Falcon Landing

7344 McLaughlin Road Falcon, Colorado 80831

INDEX OF DRAWINGS

PROJECT: BECKETT AT WOODMEN HILLS LOT 3
SHEET TITLE: SITE PLAN
FROM: n/a TO: n/a
JOB NO. 06-0056 SHEET 1 OF 1

SHEET TITLE: GRADING PLAN

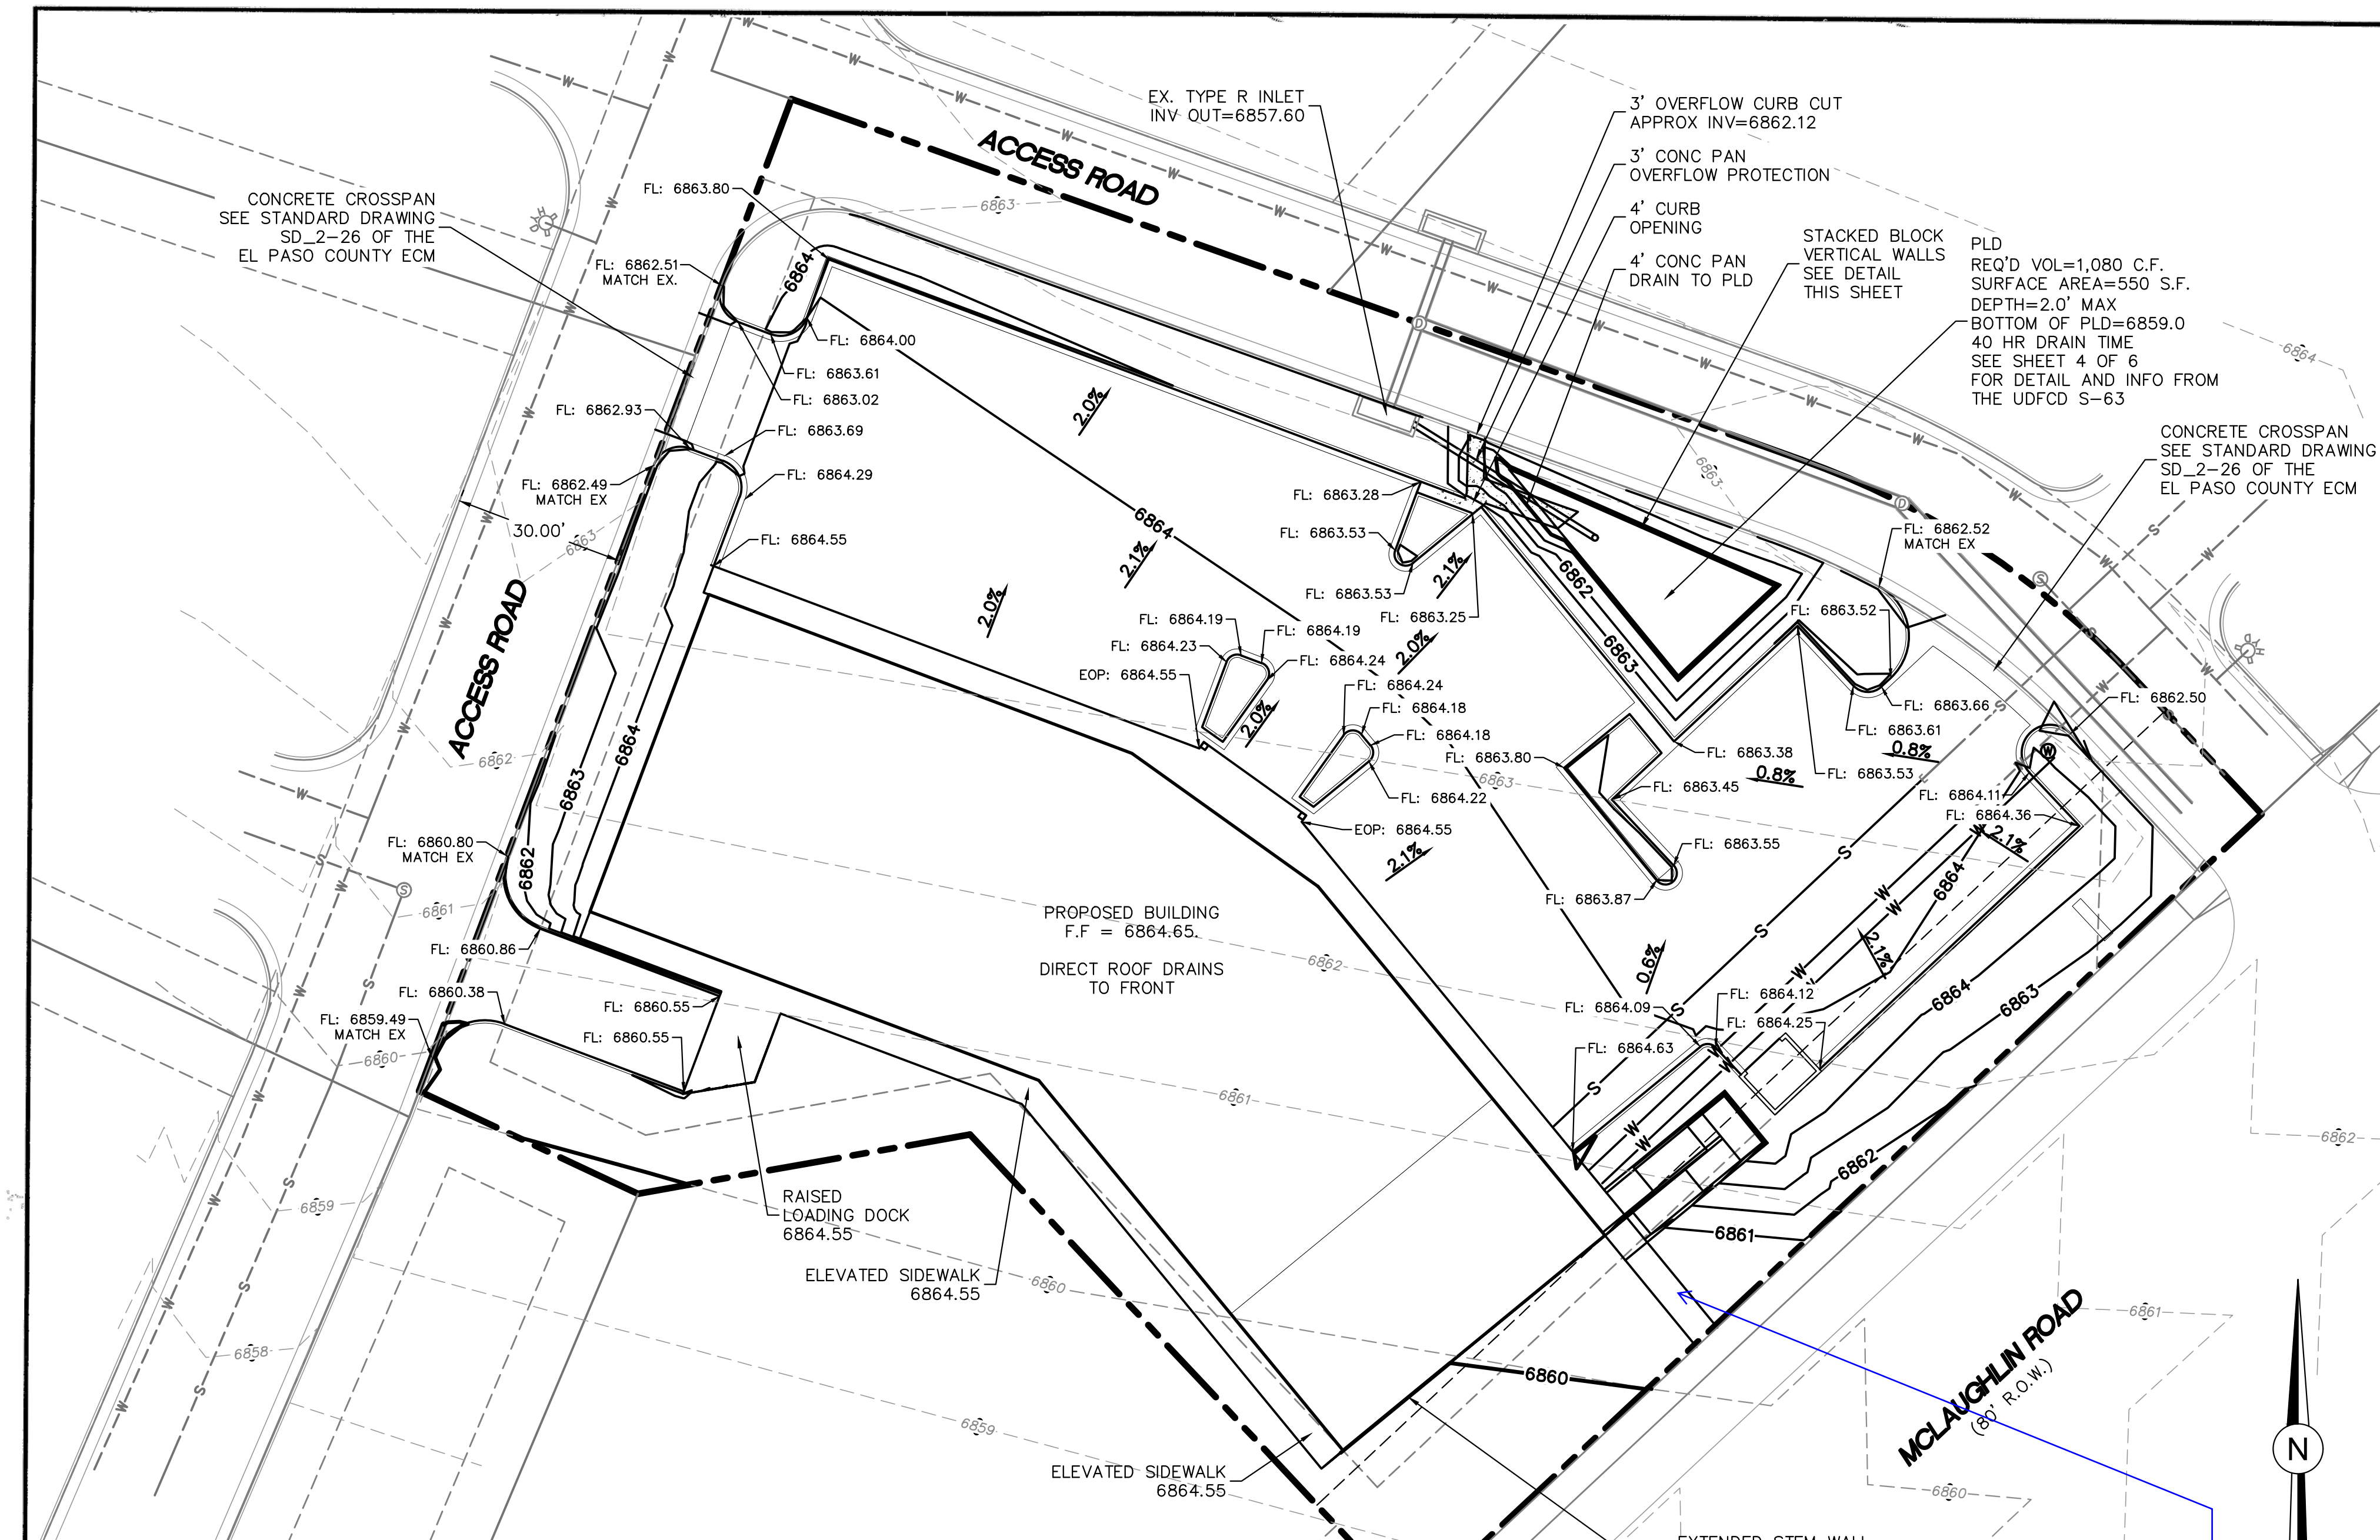
Add the following note: Certified percolation tests are required to be submitted to PCD Engineering and written approval from PCD Engineering is required prior to elimination of the Gravel layer, underdrains and geotextile fabric.

Ensure that ADA requirements are met here and throughout site. Provide the std. note on site plan sheet.

PROJECT FALCON LANDING
SHEET TITLE LIGHTING PHOTOMETRIC PLAN
FROM _____ TO _____
JOB NO. 01-13 SHEET 6 OF 9

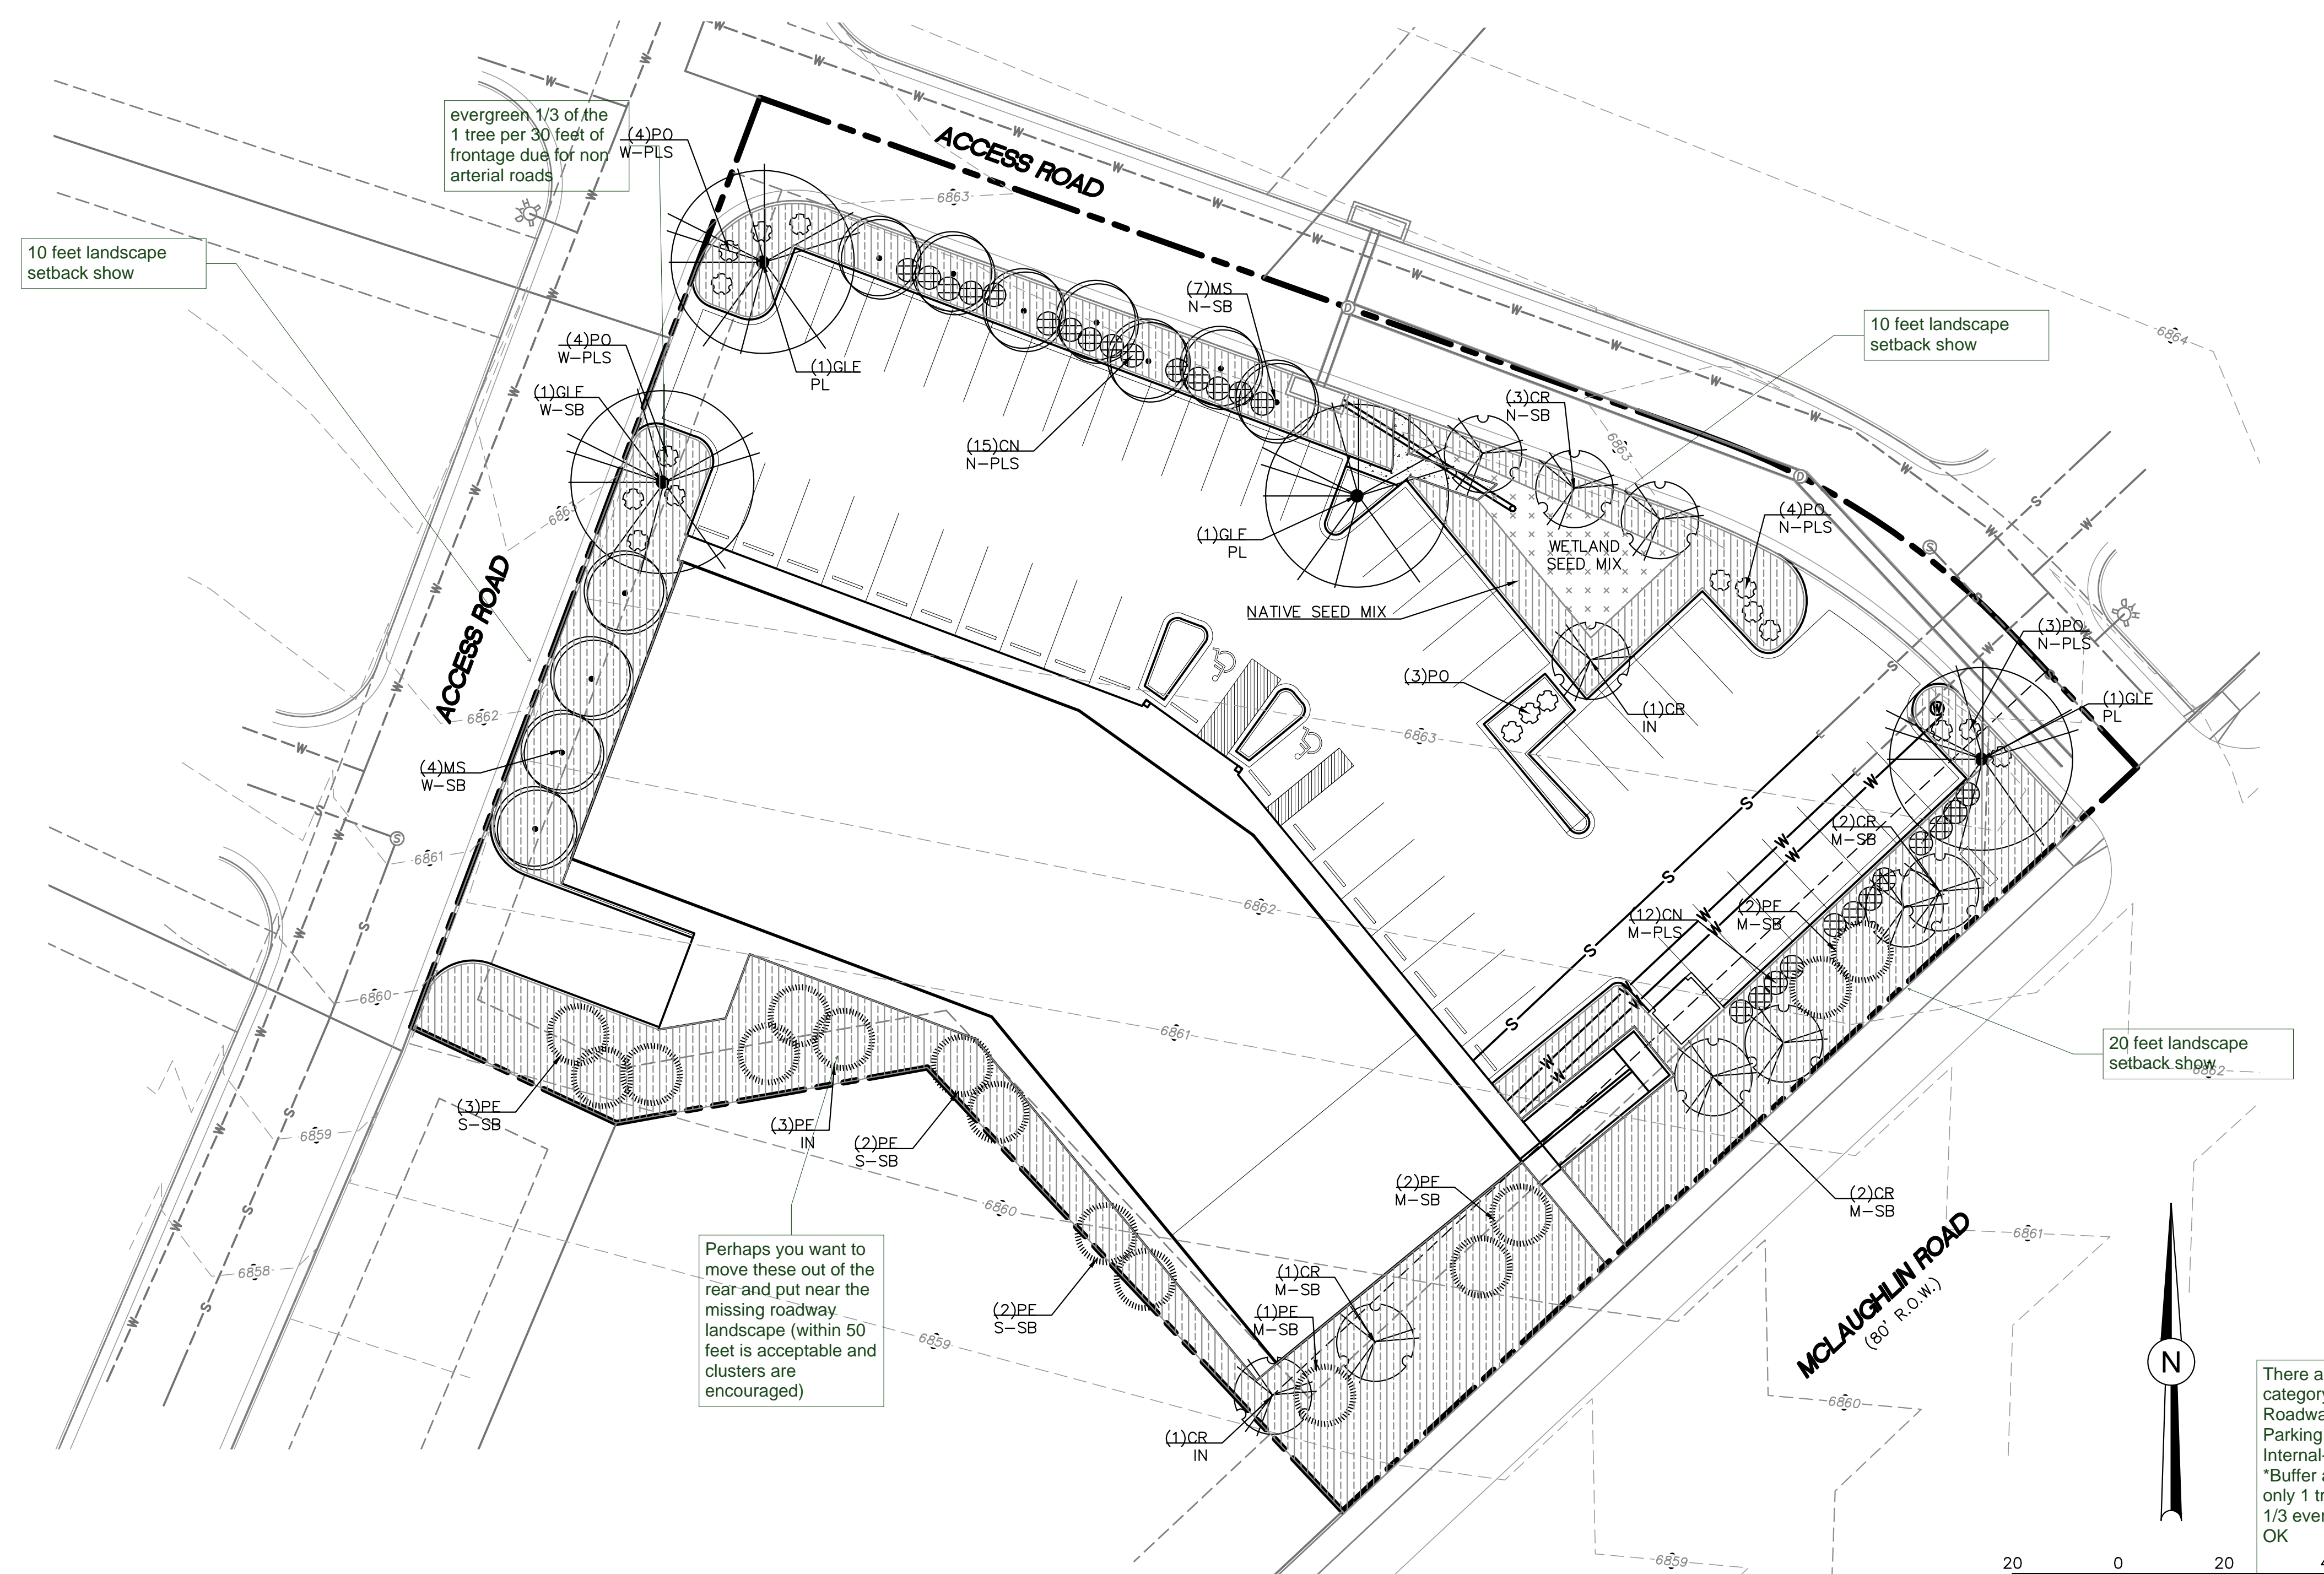
the PL candles should be at 0.1 max; perhaps if you move over or provide additional shielding or place fixture at 15 feet height that will help.

Fixture height mounting max is 15 feet 6.2.3 Code Section.

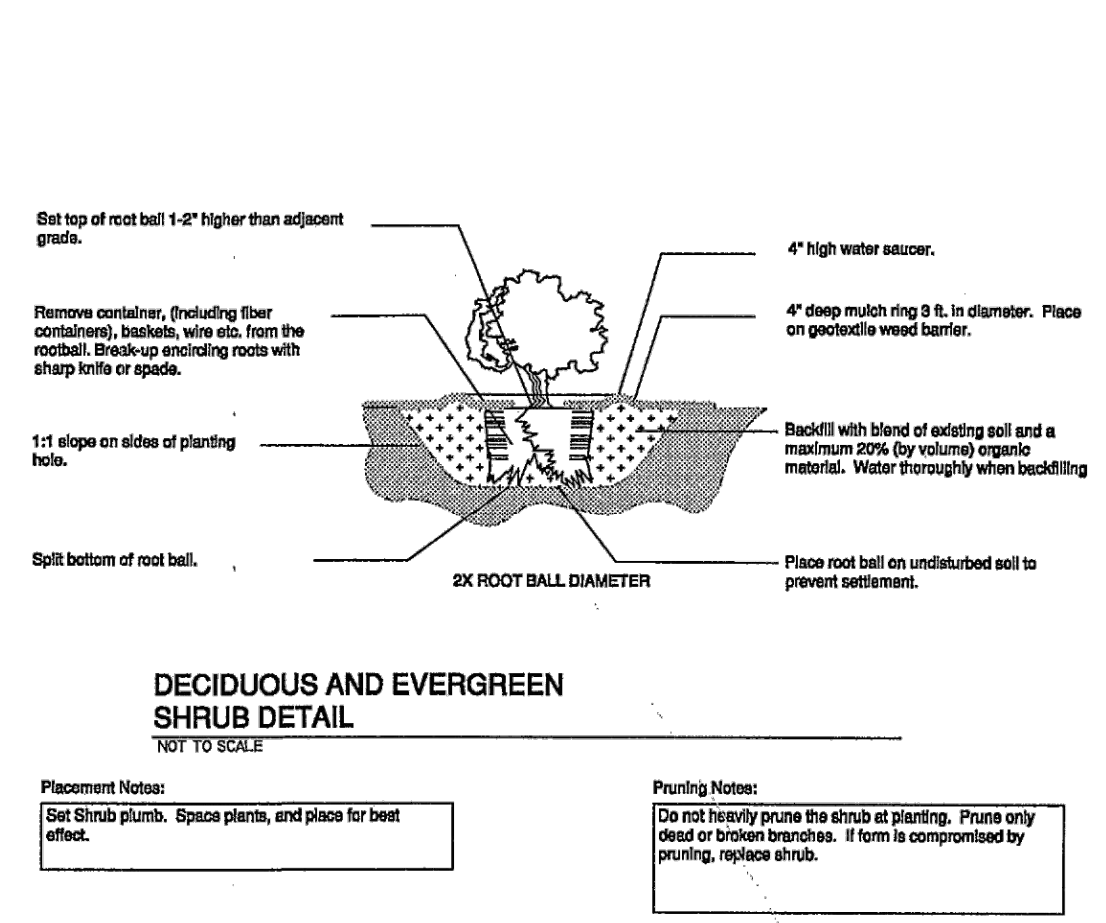
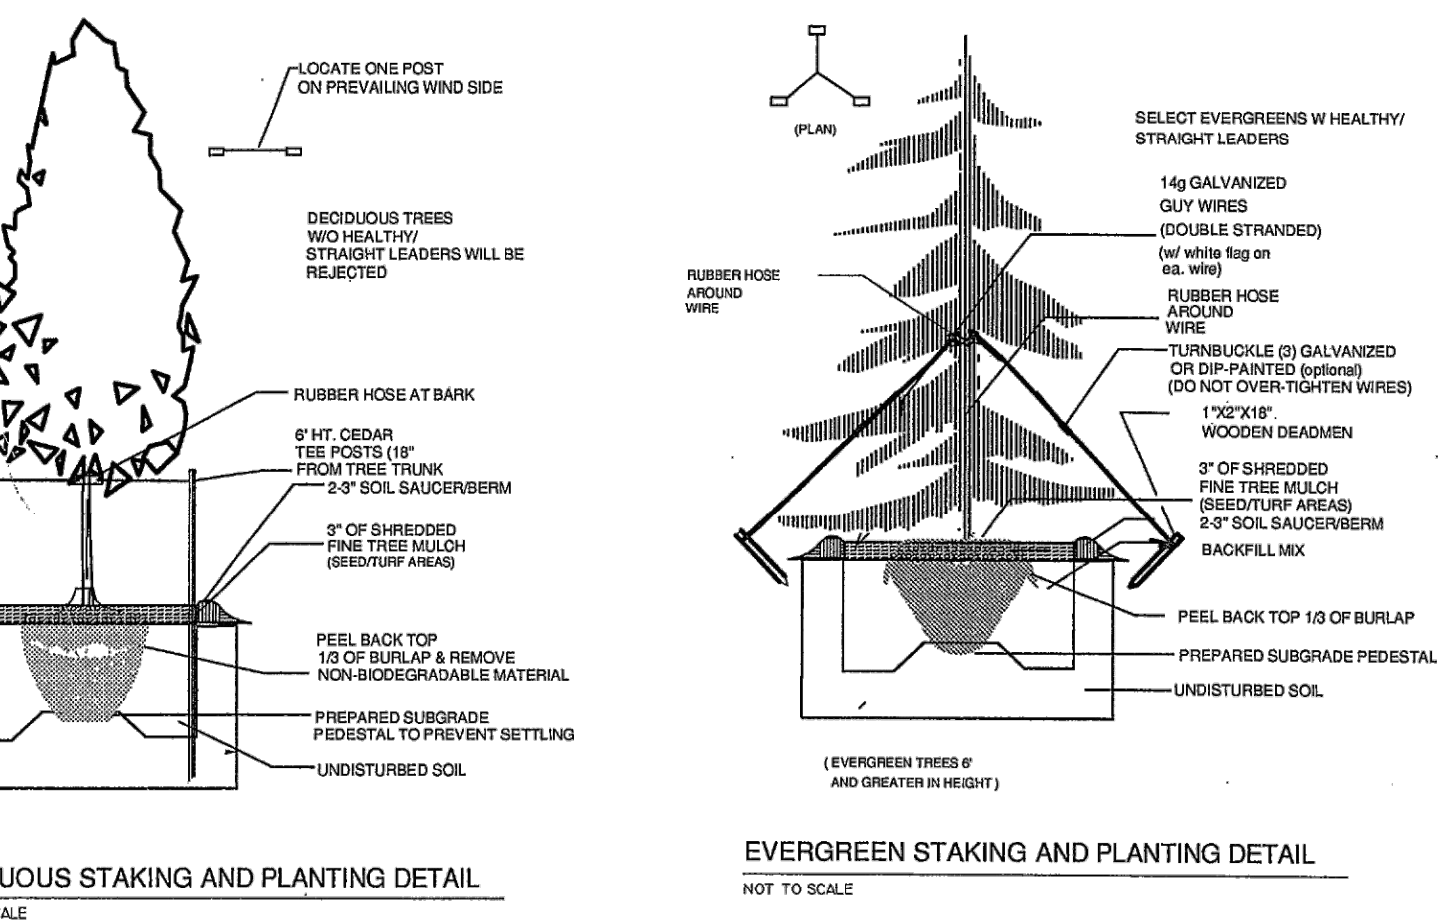
There are multiple category req: Roadway- Needs revision Internal- OK *Buffer at McLaughlin only 1 tree / 15 feet and 1/3 evergreen of those.- OK

Is setback is 20 feet- 1 tree per 25 feet

The Code includes entire lot-remove except setbacks.

we can work with you on rock or mulch in lieu of grass here

not recommended seed mix/ in non irrigated area- pond should not be retaining water.

Perhaps you want to move these out of the rear and put near the missing roadway landscape (within 50 feet is acceptable and clusters are encouraged)

evergreen 1/3 of the 1 tree per 30 feet of frontage due for non arterial roads

10 feet landscape setback show

10 feet landscape setback show

20 feet landscape setback show

20 feet landscape setback show
